**90% DESIGN DRAFT TECHNICAL DRAINAGE MEMORANDUM
FOR
RANCHO DRIVE COMPLETE STREET
MESQUITE AVENUE TO SAHARA AVENUE**

412-668

**Re: 90% Design - Draft Technical Drainage Memorandum for Rancho Drive
Complete Street – Mesquite to Sahara**

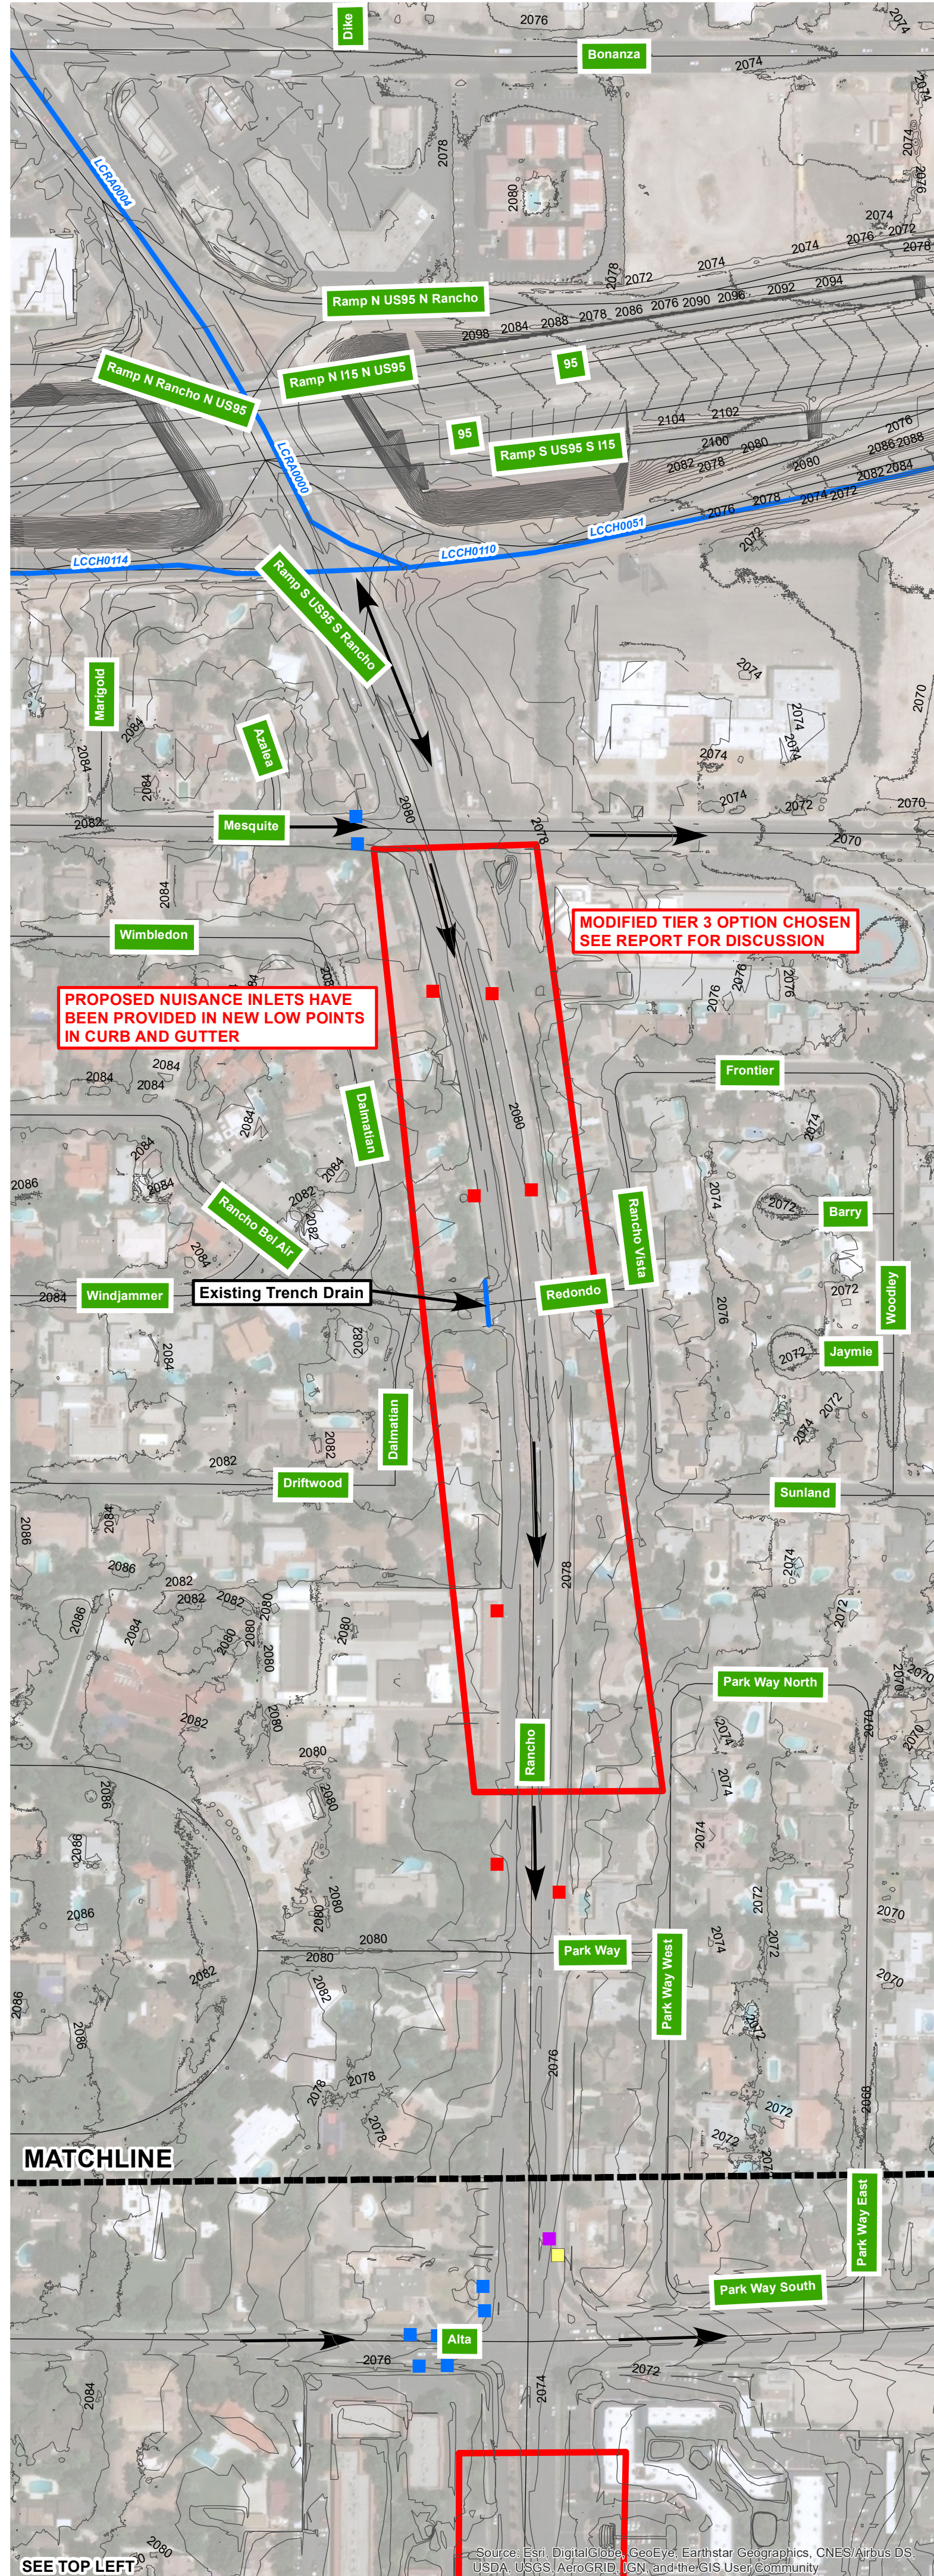
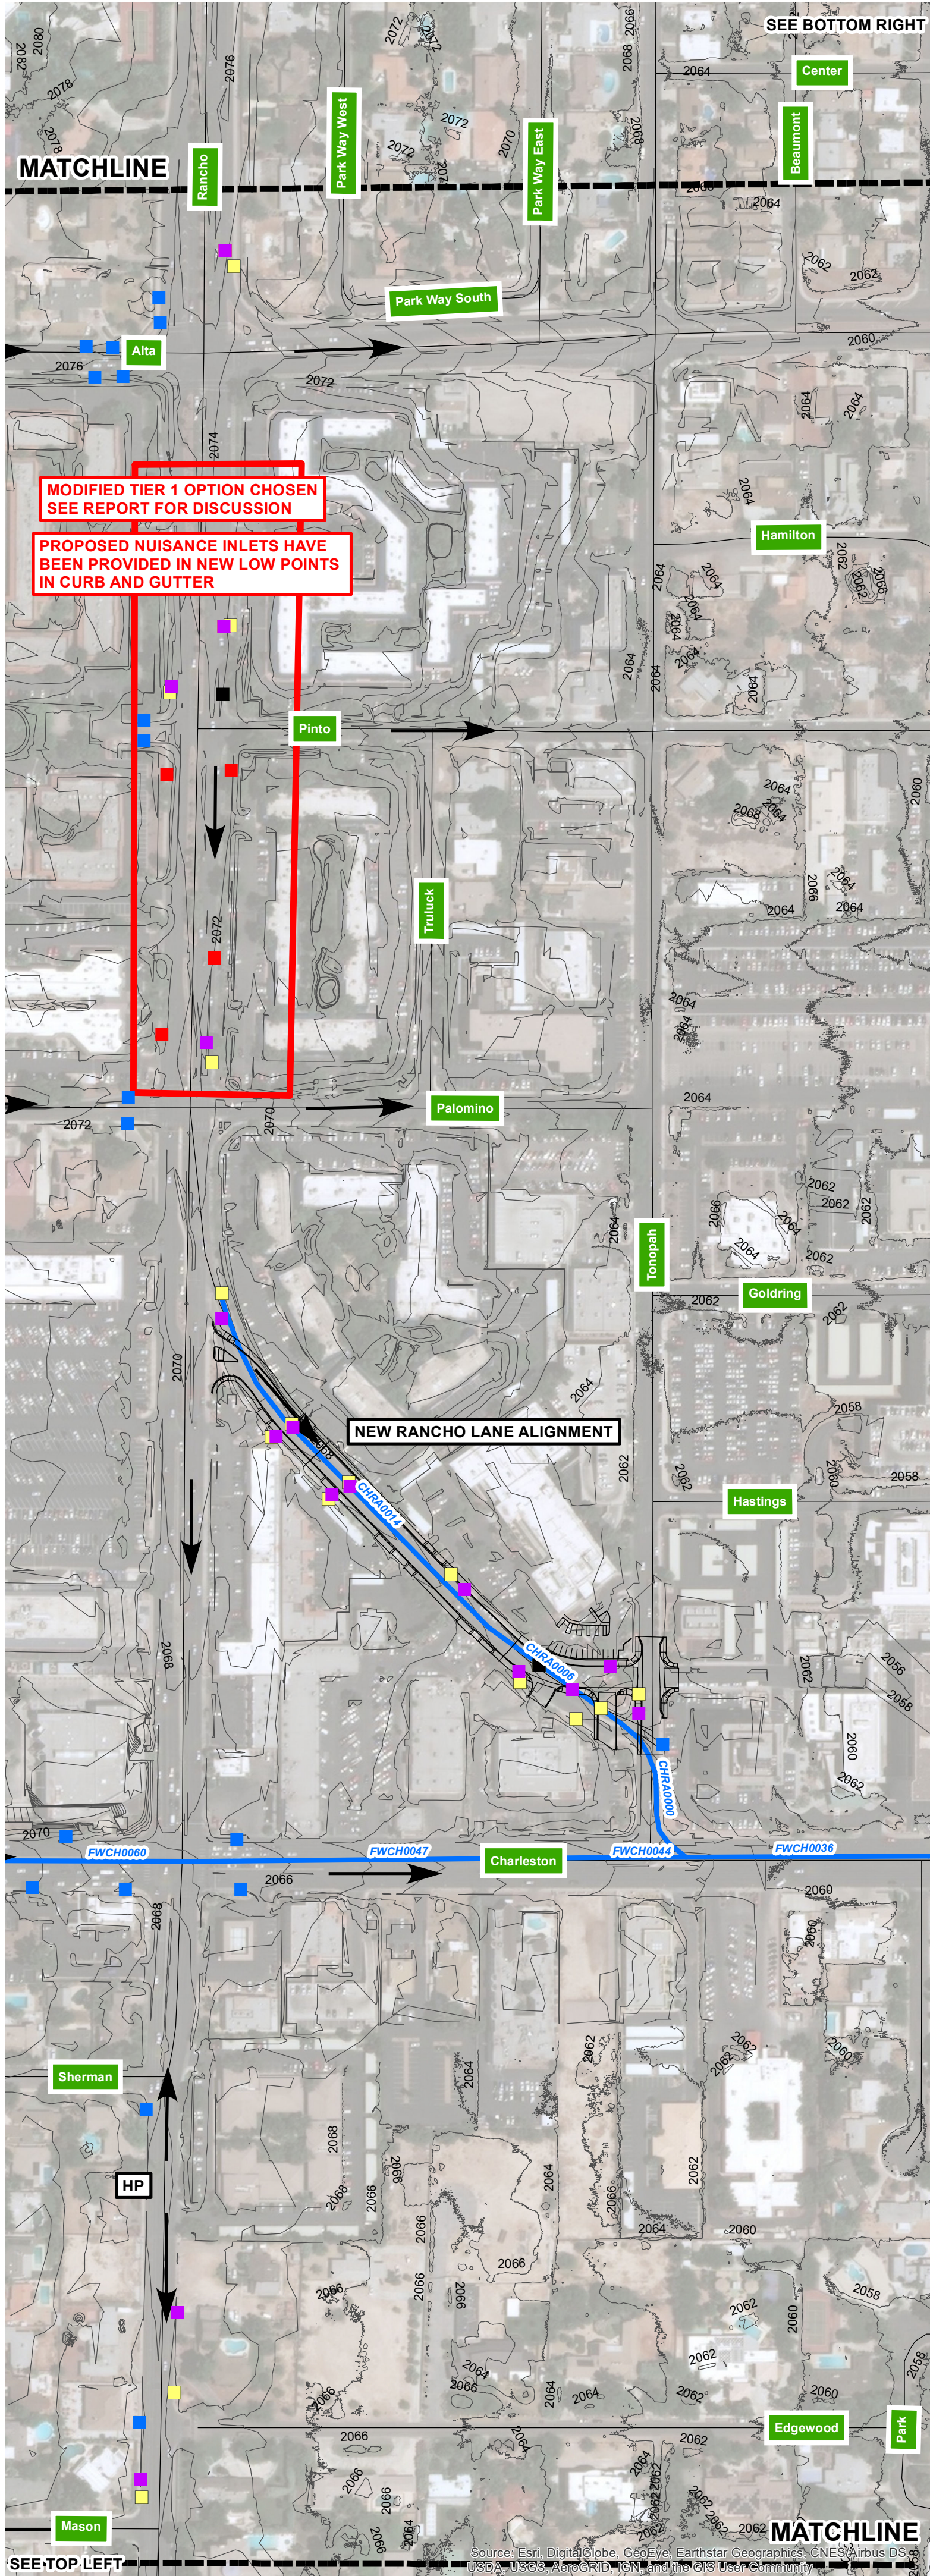
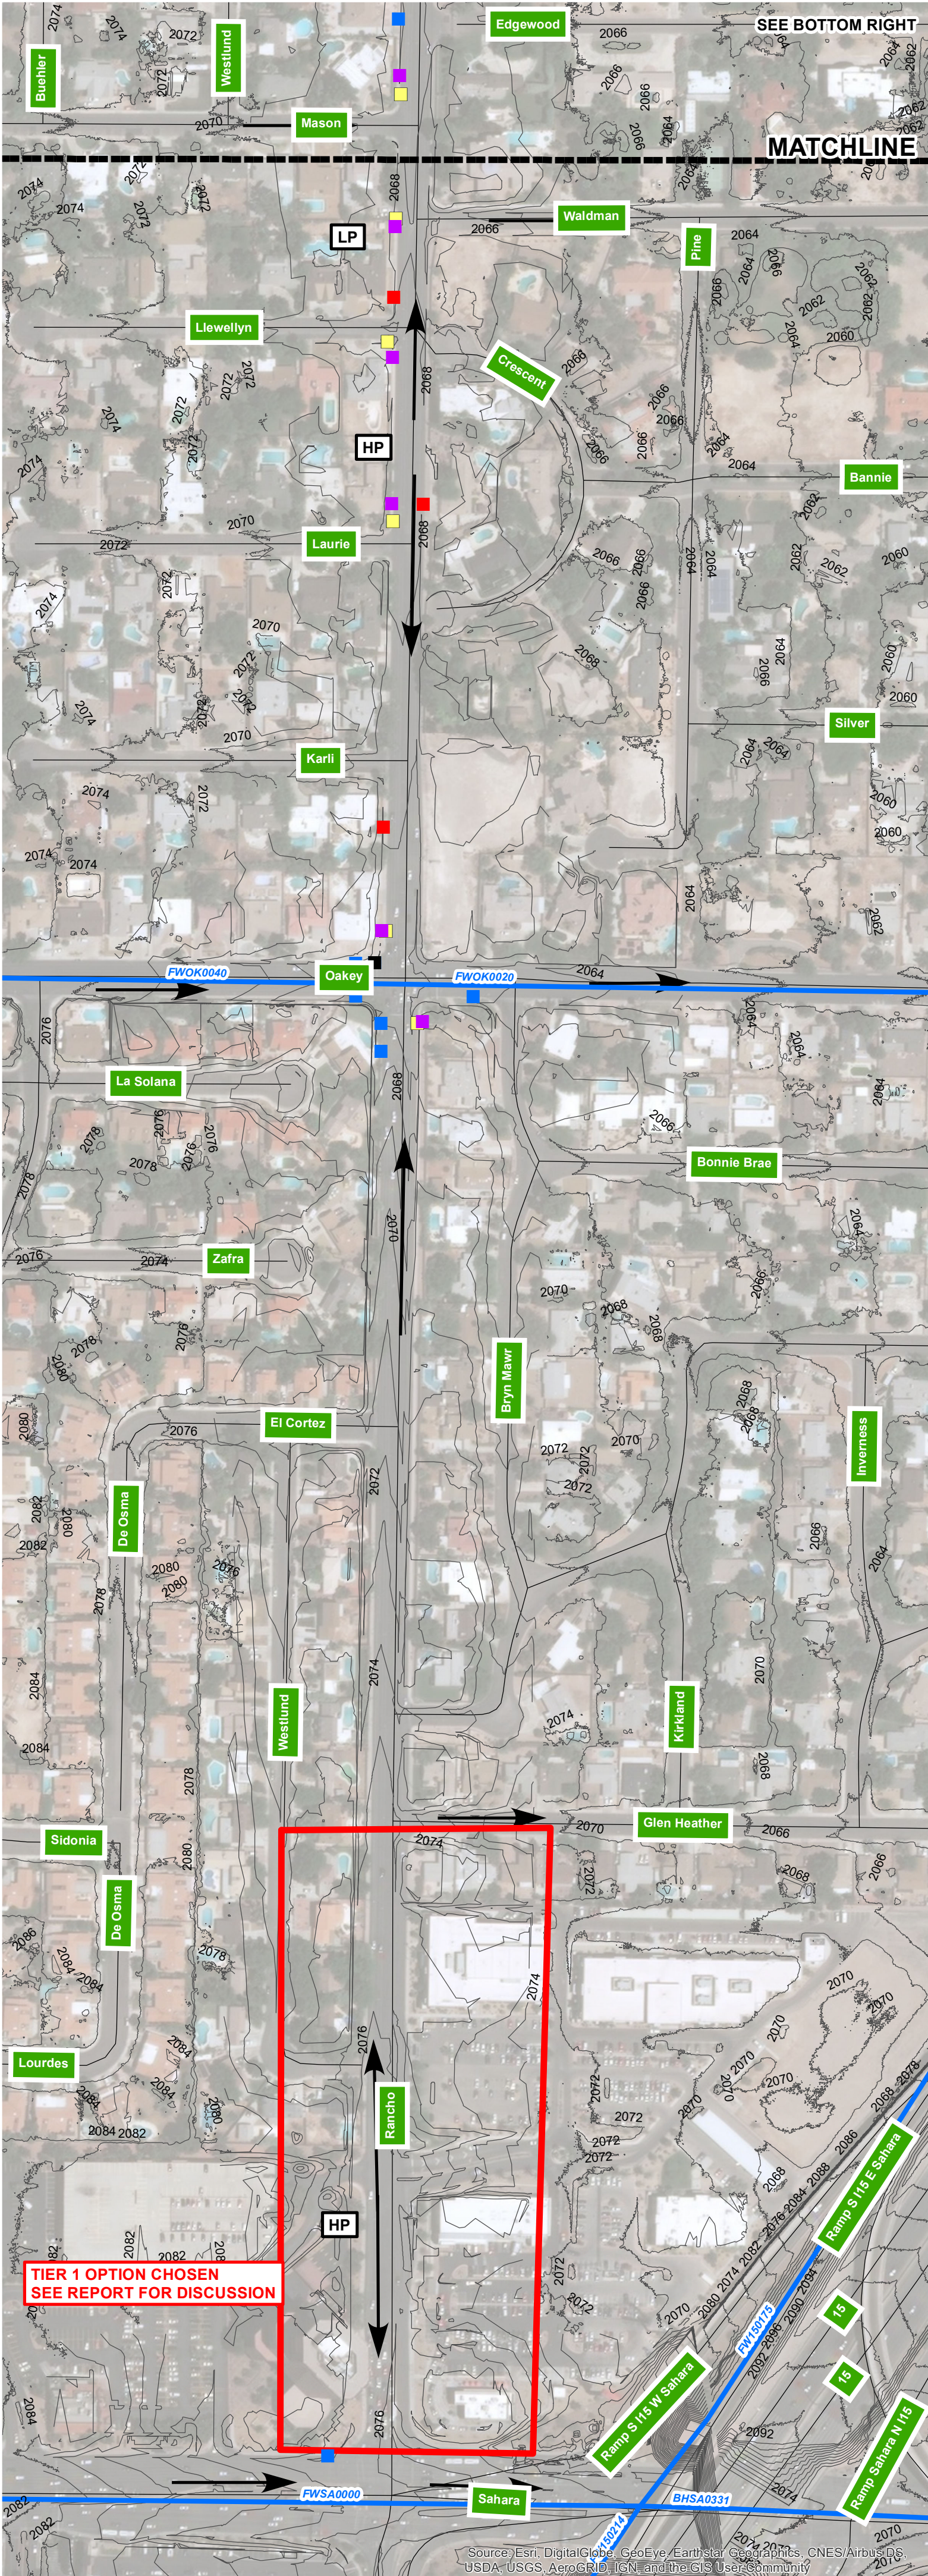
The design intent for all areas has not changed from what was submitted with the 70 Percent Design Report. In general, storm drain and drop inlets remain in relatively the same locations with the exception of one nuisance inlet on the east side of Rancho north of Pinto ("RD" 93+65) which was removed due to a conflict with the existing sewer. Note that this was a nuisance inlet and inlets are provided within 150' upstream and downstream of the previous location, therefore this has an insignificant impact. An additional inlet has also been proposed on the east side of Rancho north of Laurie ("RD" 54+85) where ponding may occur due to revised grading in the area. Grading in this area has been proposed to increase the slope of the road to allow for better drainage. Note that the location of high and low points generally match the existing locations and that inlets are provided in all low points. Figure 6 has been included with updated inlet locations.
